Daimler Trucks

Customer Advisory Letter

CAL FTL 42-004

Subject: Drive Axle Drum Brake S-Cam U-Bolt Replacement

Fig. 1, S-Cam Support

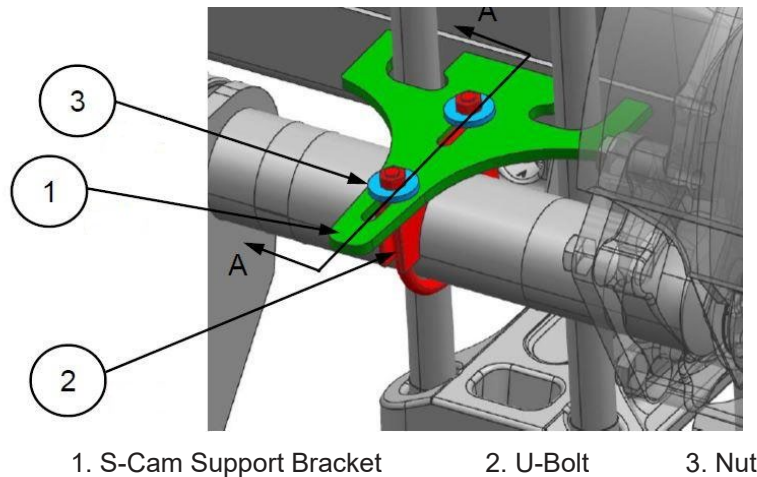
1. Park the vehicle on a level surface, shut down the engine, and apply the parking brakes. Chock the tires.
2. Remove and discard the original S-cam support U-bolt. See **Fig. 1**.

3. Install the new U-bolt provided by your DTNA Field Representative.
4. Torque the nuts to 11 lbf•ft (15 N•m).
5. Document all vehicles retrofitted with the new U-bolt; send this documentation to your DTNA Field Representative.
